# **Manual 03A, Rev. 25**

## **Energy Management System (EMS) Model Updates and Quality Assurance (QA)**

Operating Committee

Oct 10, 2024

Exhibit 10: Sample Format for 6-Week Look Ahead Cut-in Report

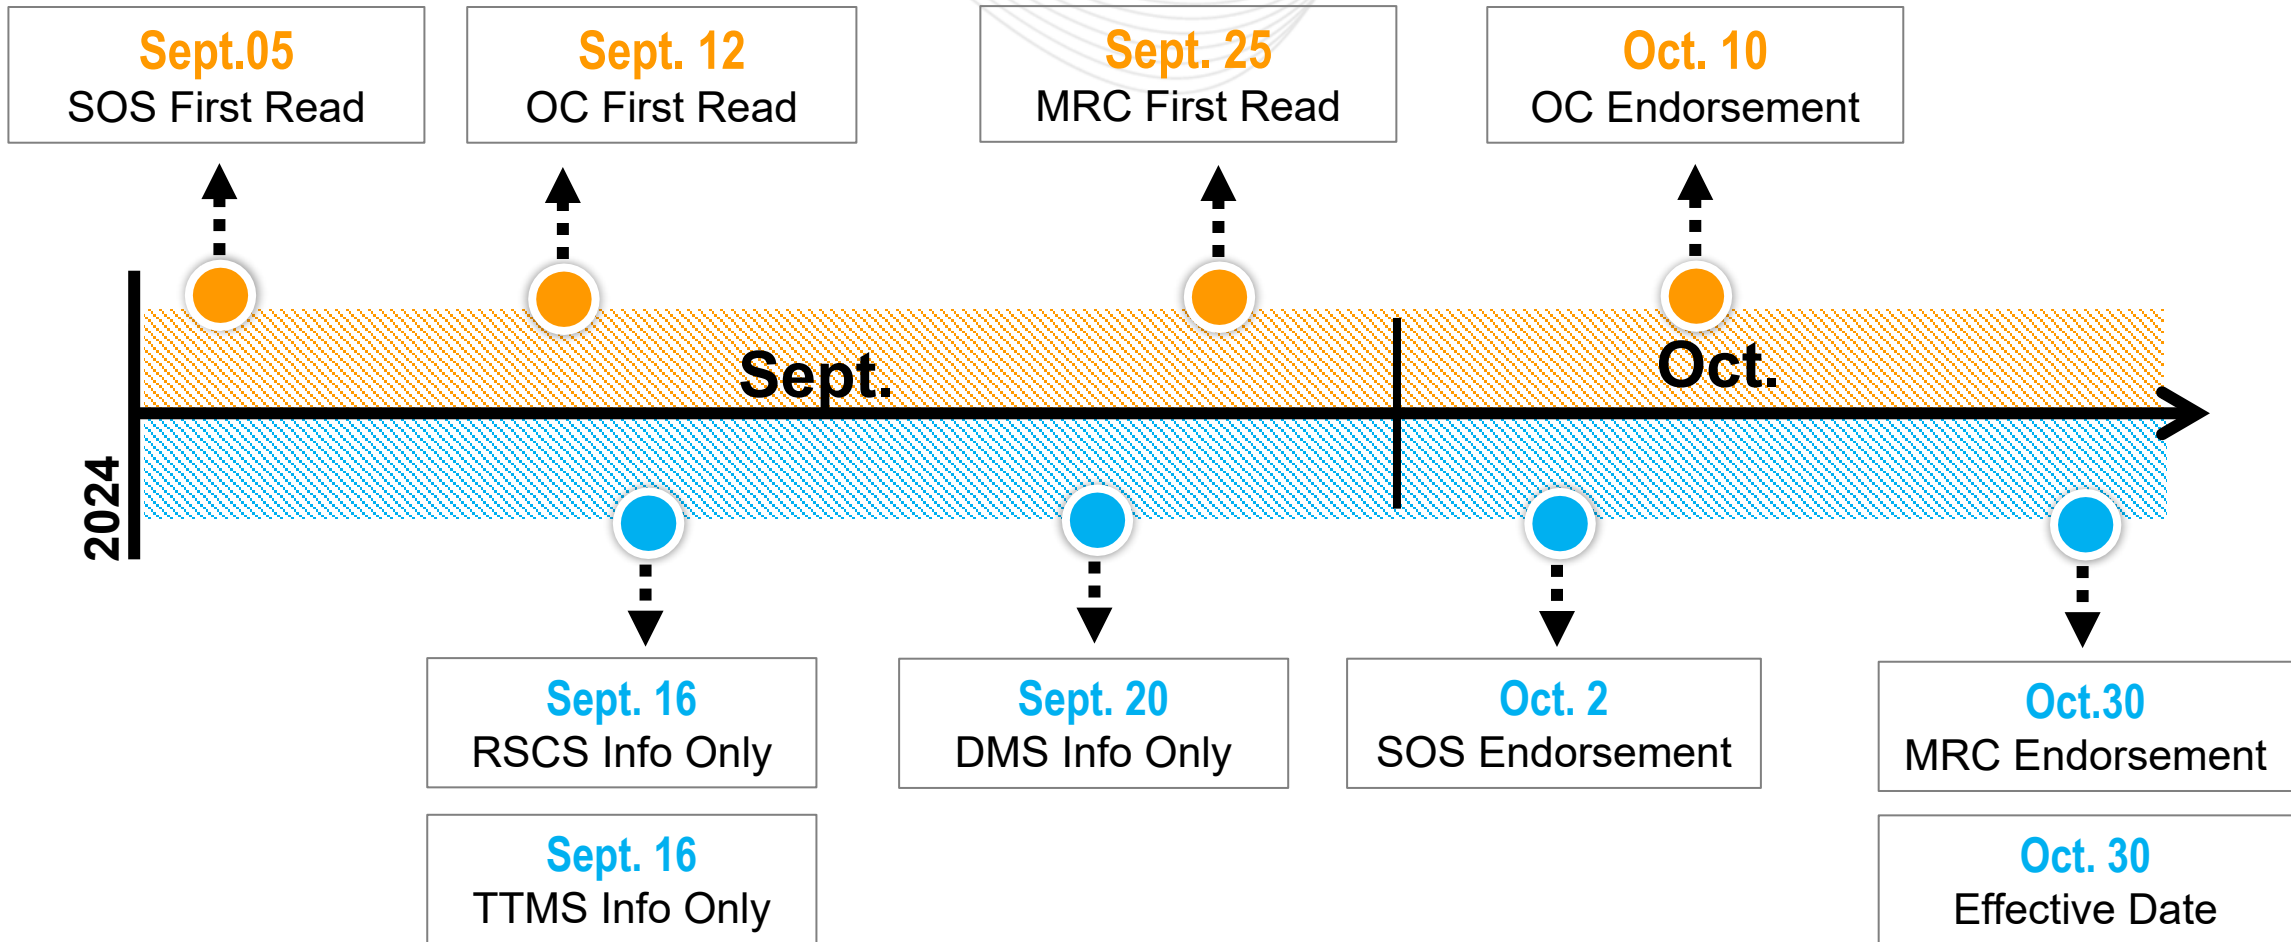
# Section 4.5: Removed Exhibit 10

- Remove Exhibit 10  
Outdated process was replaced via “Cut-in Barron” weekly reports

To facilitate the Cut-in process, PJM performs outreach to each TO with Cut-in related work in the Operations time horizon. will publish a weekly list of scheduled outages in eDART that have the Cut-in flag set. The reports include a six (6)-week look-ahead of all outages tickets that have the Cut-in flag set. See Exhibit 10 below.
